# Service Bulletin

Bulletin No.: 16-NA-126

**Subject: Battery Goes Dead Intermittently with No Parasitic Drain Noted**

Brand:	Model:	Model Year:		VIN:		Engine:	Transmission:
		from	to	from	to		
Buick	Cascade	2016	2016	SOP	GG088621

4587078

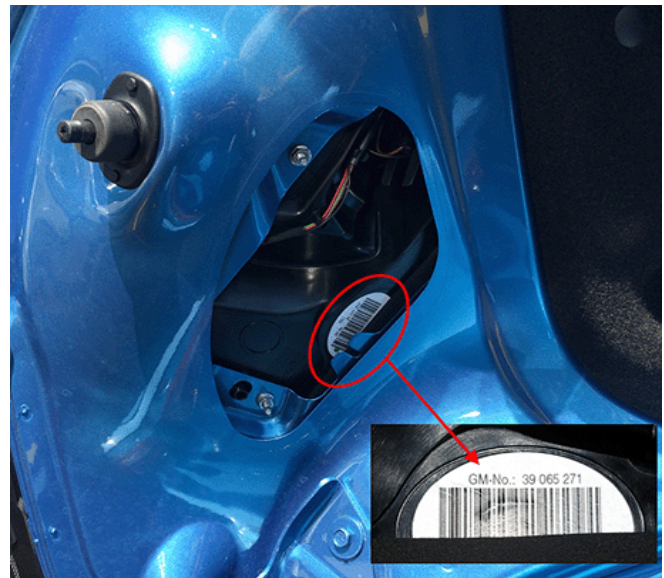
1. Open the rear compartment lid.
2. Remove the rear tail lamp access hole cover nut (1).
3. Remove the tail lamp access hole cover (2).
